# UNITED STATES PATENT AND TRADEMARK OFFICE

APPLICATION NO.	FILING DATE	FIRST NAMED INVENTOR	ATTORNEY DOCKET NO.	CONFIRMATION NO.
10/715,376	11/19/2003	Jonathan Zanhong Sun	YOR920030332US1	5483
21254	7590	08/17/2005	EXAMINER	
MCGINN & GIBB, PLLC 8321 OLD COURTHOUSE ROAD SUITE 200 VIENNA, VA 22182-3817			NGUYEN, THINH T	
			ART UNIT	PAPER NUMBER
			2818

**Office Action Summary**

### **DETAILED OFFICE ACTION**

**FIG. 1****FIG. 2****FIG. 3**

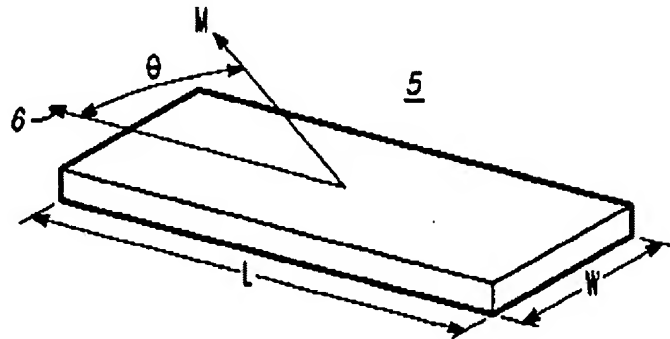
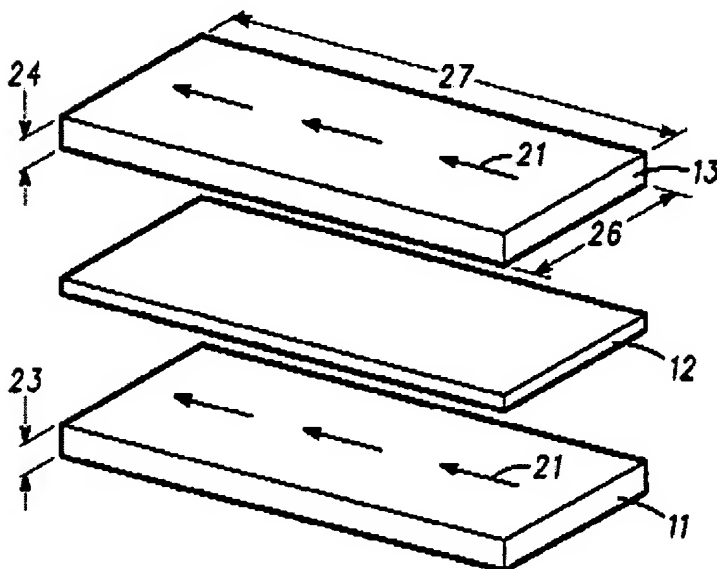
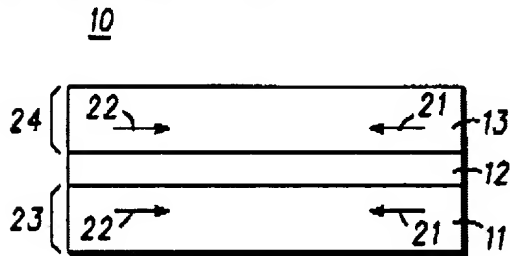
Chen ( fig 1,fig2,fig 3, column 2 lines 40-44,column 4 line 40) discloses a spin-current switched magnetic memory element, comprising: a plurality of magnetic layers, at least one of the plurality of magnetic layers ( fig 3 layer 11,13) having a perpendicular magnetic anisotropy

component and comprising a current-switchable magnetic moment; and at least one barrier layer( fig 3 layer 12) formed adjacent to the plurality of magnetic layers.

Chen discloses ( fig 3) a spin-switched magnetic element wherein the plurality of magnetic layers comprises an upper magnetic layer ( fig 3 layer 13 ) and a lower magnetic

layer ( fig 3 layer 11) , the at least one barrier layer ( fig 3 layer 12) being formed between the upper and lower magnetic layers.

FIG. 8

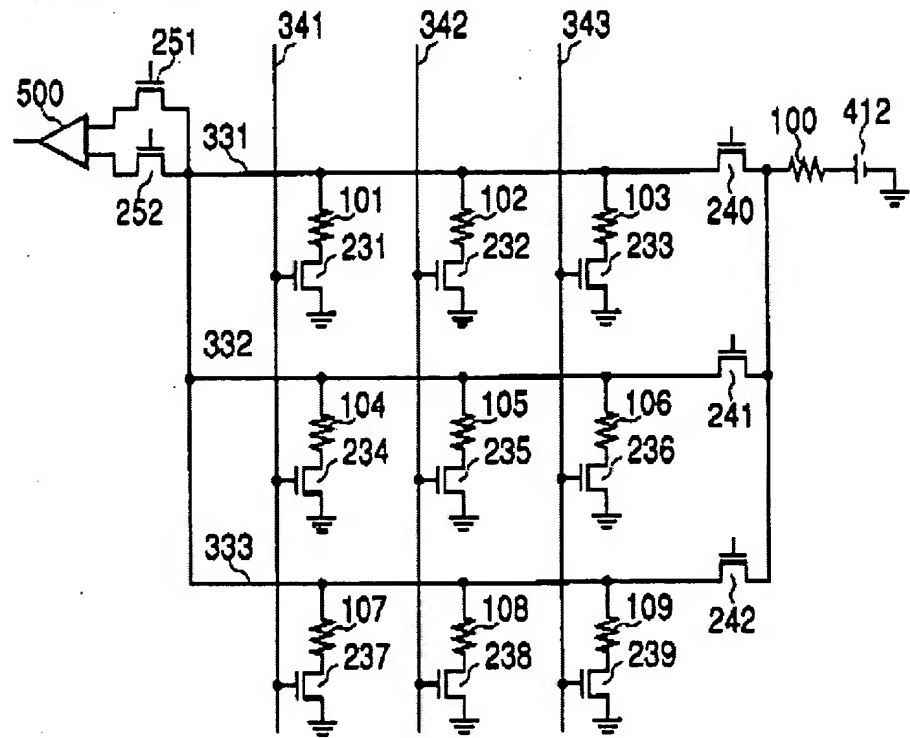
Ikeda ( Fig 8) discloses a memory array comprising of magnetic spin current switched magnetic elements

FIG. 9

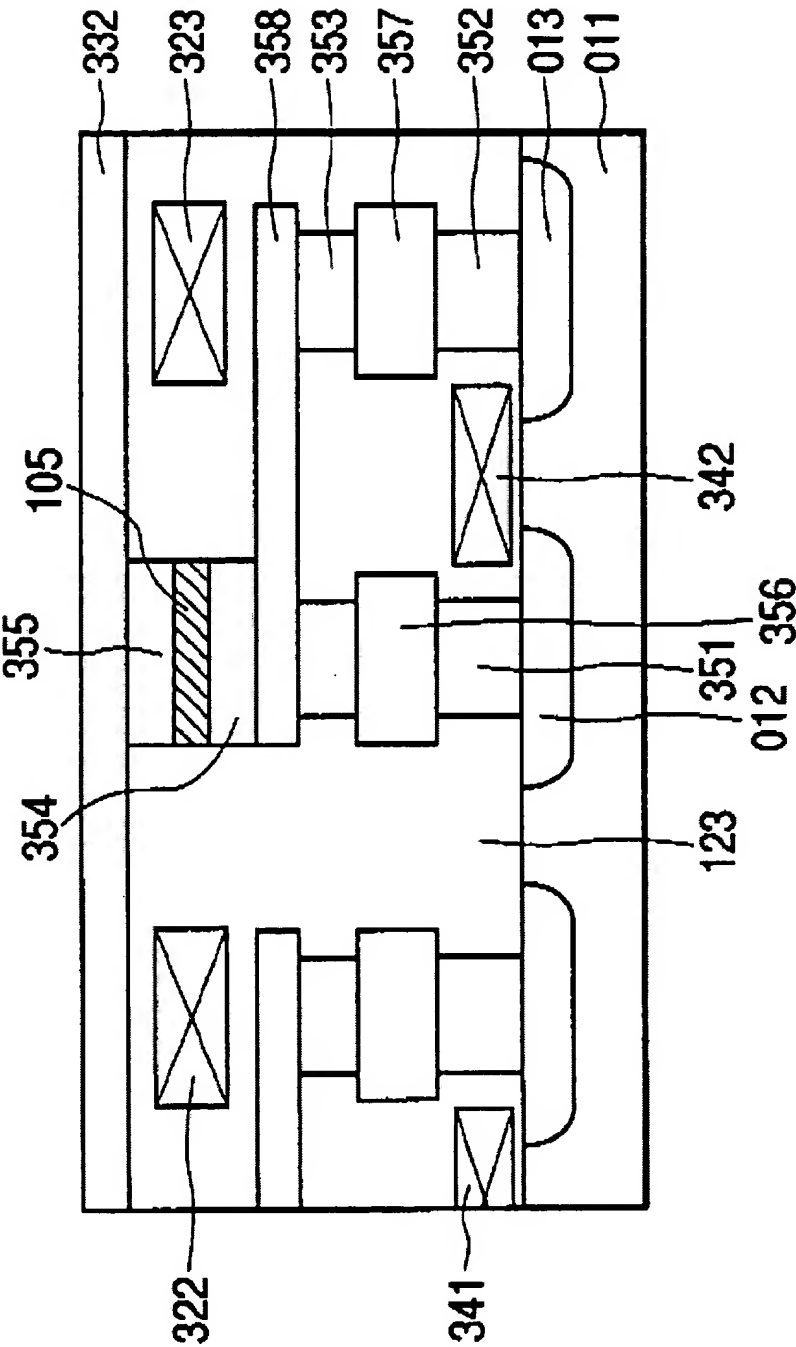
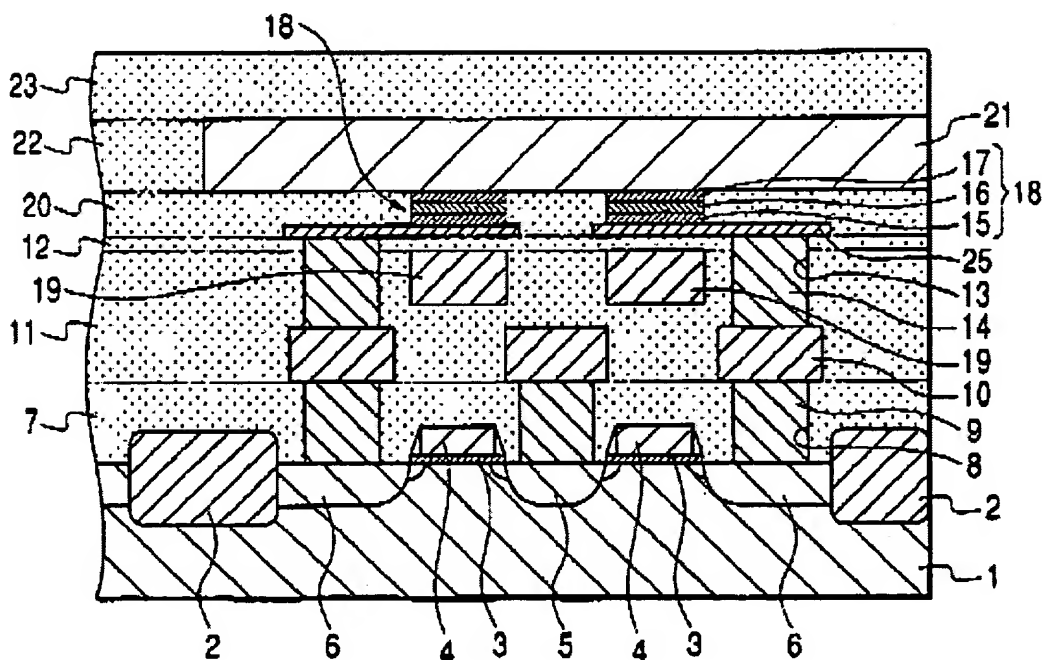
Ikeda ( in the abstract , in fig 9) discloses a spin-current switched magnetic memory element, comprising: a plurality of magnetic layers fig 9 layer 355,354), at least one of the plurality of magnetic layers having a perpendicular magnetic anisotropy component ( the abstract lines 3-4) and comprising a current-switchable magnetic moment; and at least one barrier layer ( fig 9 layer 105 ) formed adjacent to the plurality of magnetic layers and wherein said plurality of magnetic layers comprises at least one composite layer ( the abstract lines 5-7) . Noted that Ikeda discloses a tunneling magnetoresistive device ( column 7 lines 5-6 ) therefore it is inherently a spin switched magnetic memory device.

Ikeda ( in the abstract , in fig 9) discloses a spin-current switched magnetic memory element comprising: first and second leads ( fig 9 layer 332 layer 358 ) ; and a pillar formed between said first and second leads, said pillar including said at least one barrier layer (fig 9 layer 105) and at least one magnetic layer ( fig 9 layer 354 or 355 ) of said plurality of magnetic layers.

Ikeda ( in the abstract , in fig 9) discloses a spin-current switched magnetic memory element, comprising: first and second leads ( fig 9 layer 332 and 358) ; formed between the first and second leads, a plurality of magnetic layers( fig 9 layers 355,354) , at least one of the plurality of magnetic layers having a perpendicular magnetic anisotropy component ( the abstract ) and comprising a current-switchable magnetic moment; wherein one barrier layer comprise a tunneling barrier ( column 7 line s 5-6 ) and comprises Aluminum Oxide ( column 7 lines 5-10) .

Ikeda ( in the abstract , in fig 9) discloses a spin-current switched magnetic memory element, comprising: first and second leads ( fig 9 layer 332 and 358) ; formed between the first and second leads, a plurality of magnetic layers( fig 9 layers 355,354) , at least one of the plurality of magnetic layers having a perpendicular magnetic anisotropy component ( the abstract ) and comprising a current-switchable magnetic moment; and at least one barrier layer ( fig 9 layer 105) formed in the pillar adjacent to the plurality of magnetic layers. Noted that Ikeda discloses a tunneling magnetoresistive device ( column 7 lines 5-6 ) therefore it is inherently a spin switched magnetic memory device.

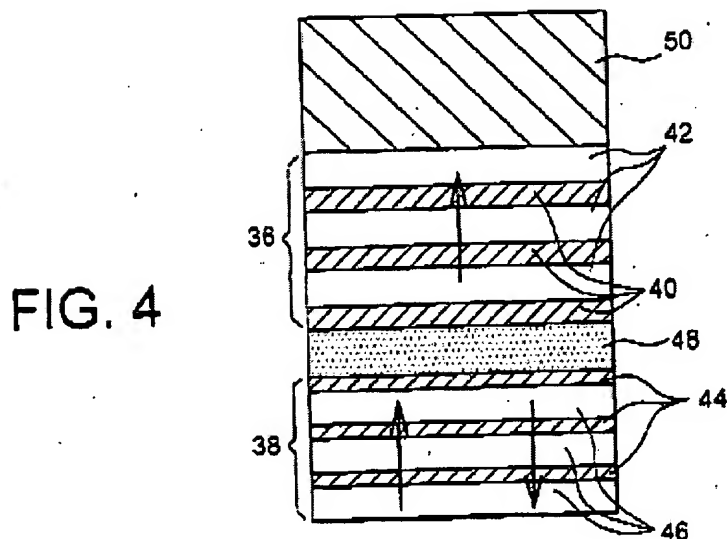
Similarly Dieny et al. (fig 3, paragraph [0118], paragraph [0122], magnetic layer 20a, magnetic layer 20c, barrier layer 20b disclose the same invention.

Dieny et al. ( fig. 3, paragraph [0118], paragraph [0122] ) discloses a spin-current switched magnetic memory element wherein the at least one composite layer comprises a platinum layer and a cobalt layer.

Dieny et al. ( fig. 3, fig 4, paragraph [0118], paragraph [0125] ) discloses a spin-current switched magnetic memory element wherein the at least one composite layer comprises a Nickel ( Ni ) layer and a copper (Cu) layer.
